**FILE NUMBER:** Z212-271(JA)                      **DATE FILED:** May 25, 2022  
**LOCATION:** Northeast corner of Linfield Road and Bonnie View Road  
**COUNCIL DISTRICT:** 4  
**SIZE OF REQUEST:** Approx. 10.19 acres                      **CENSUS TRACT:** 48113008703

**REPRESENTATIVE:** Karl A. Crawley, Masterplan  
**APPLICANT/OWNER:** Dallas Independent School District  
**REQUEST:** An application for a Specific Use Permit for a public school other than an open-enrollment charter school on property zoned an R-5(A) Single Family District.  
**SUMMARY:** The purpose of the request is to allow for the construction of a new public school to replace the existing public school. [W.W. Bushman Elementary School]  
**STAFF RECOMMENDATION:** Approval, subject to a revised site plan, a revised traffic management plan, and conditions.

## STAFF COMMENTS ON PROPOSED SUP SITE PLAN

**1** Traffic Management Plan  
Not to Scale

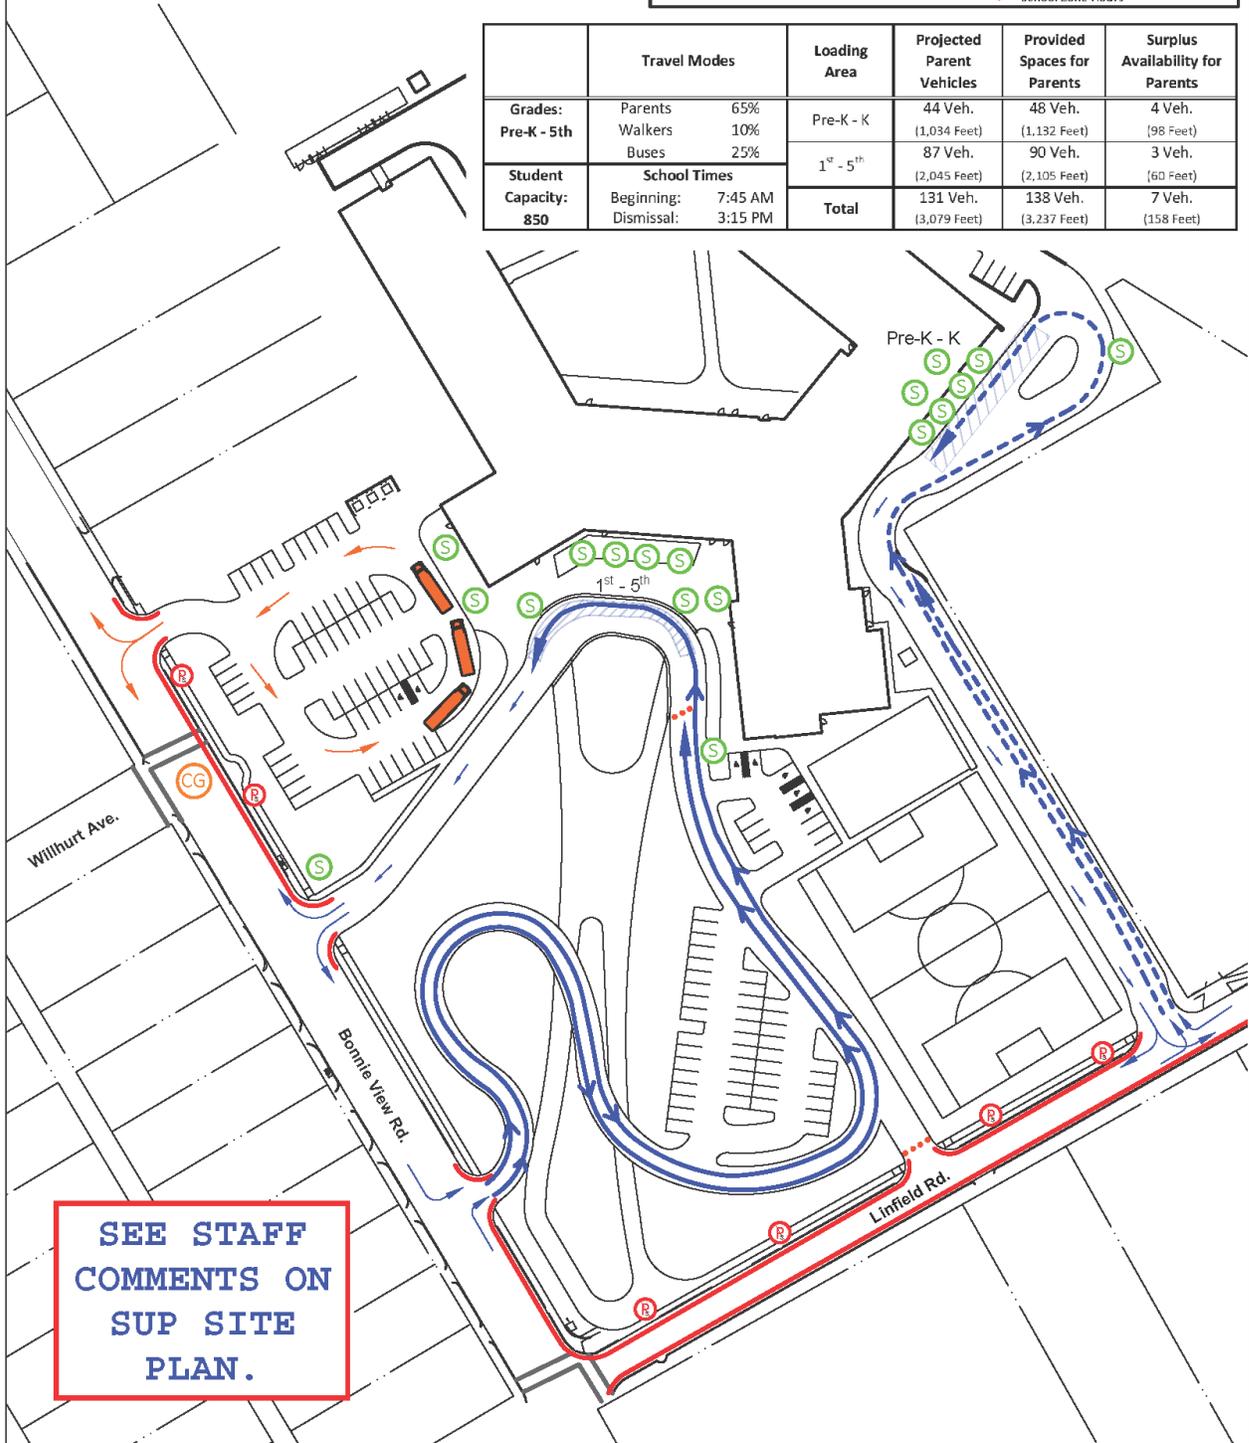
4. SHOW VISIBILITY TRIANGLES AT ALL POINTS OF INGRESS/EGRESS, AND REVISE PLAN TO REMOVE VISIBILITY OBSTRUCTIONS.
5. EXTEND THROAT OF DRIVEWAY ON LINFIELD TO AVOID ABRUPT TURN SINCE DESIGN DOES NOT PHYSICALLY DISCOURAGE WRONG WAY TURNS.  
--> TMP DOES NOT SHOW THIS DRIVEWAY AS ONE-WAY OPERATIONS. NOT APPROVABLE AT PERMITTING AS CURRENTLY PROPOSED.

6. ADD PAVED PEDESTRIAN PATH ALONG CIRCUITOUS DRIVEWAYS AND/OR PEDESTRIAN ROUTES THROUGH THE CAMPUS FROM ALL ACCESS POINTS.  
--> TMP DOES NOT SHOW ANY PEDESTRIAN RESTRICTIONS. AS CURRENTLY PROPOSED, THE DESIGN WILL NOT DISCOURAGE ACCESS TO PEDESTRIANS BUT WILL CREATE UNSAFE CONDITIONS FOR STUDENTS INSTEAD. NOT APPROVABLE AT PERMITTING AS CURRENTLY PROPOSED.

**SEE STAFF  
COMMENTS ON  
SUP SITE  
PLAN.**
